Sydney Steel Mill Modification 6

Storage and Transformer Changes
State Significant Development Modification Assessment
(DA11/94-Mod-6)

December 2021

Published by the NSW Department of Planning, Industry and Environment

Figure 3 | Proposed Switchyard Transformer and Bund location and Tree Removal

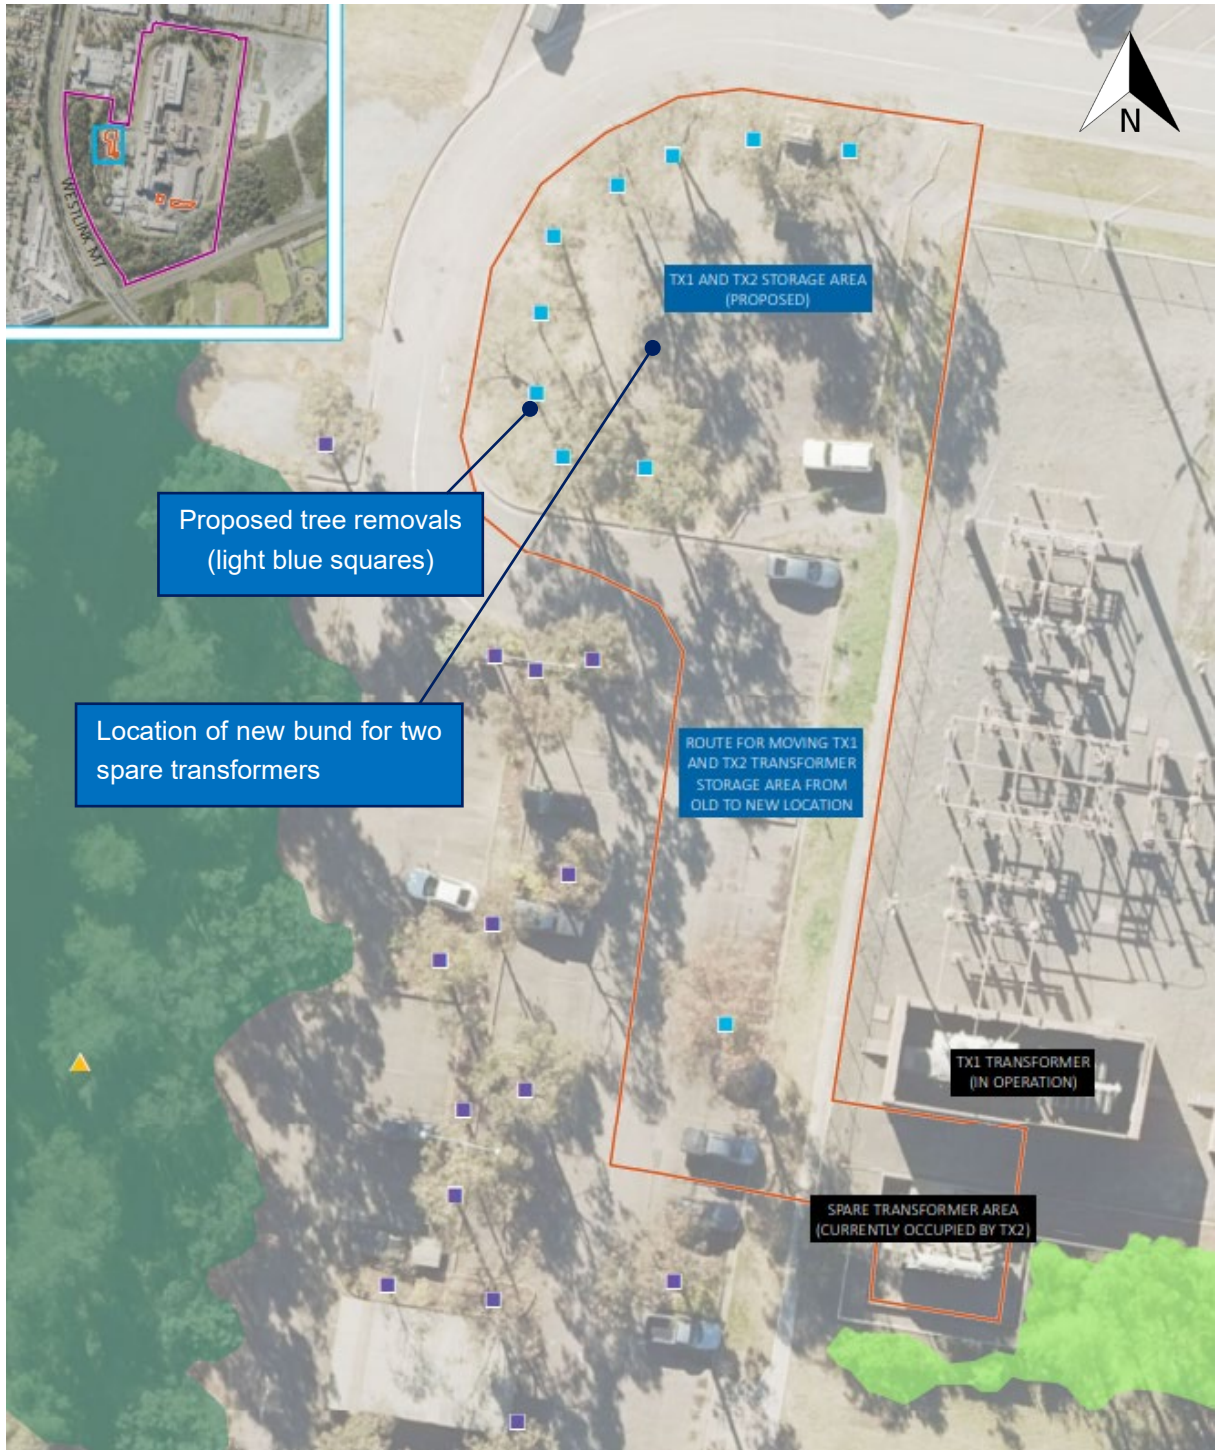
To facilitate these work, 10 trees around the carparking area are proposed to be removed (see **Figure 3**) to facilitate construction works.

The modification seeks to remove 10 trees adjoining the carpark in order to install the new transformer bunds. These trees were planted as part of the original development and no vegetation in its natural

Council did not support the proposal on the basis of insufficient information. It requested further details on modelling of the development's stormwater quality and requested an arboriculture impact assessment to understand what trees need to be removed and what trees will be retained and how these trees will be protected.

- The modification seeks to install two concrete bunds (113.2 m² and 116.3 m² in size) in areas that are currently pervious. The increase in impervious area on the site has potential to impact on the stormwater output of the development.

Council reviewed the RtA and advised it no longer had concerns with the proposal. It recommended two conditions to ensure the trees not proposed for removal are protected and retained. It also recommended an arborist mark the trees for removal.

- In its RtA, the Applicant provided further details on the stormwater management of the bund. It advised the bunds would not be connected to the existing stormwater system and therefore have no impact on stormwater quality or quantity.

- The Department is satisfied the bunds will be appropriately designed and operated to isolate water captured in the bunds and dispose of it through classified waste processes. As such, while the impervious area of the site is increasing through the construction of the bunds, it will not add to or impact on the site's existing stormwater quantity or quality.
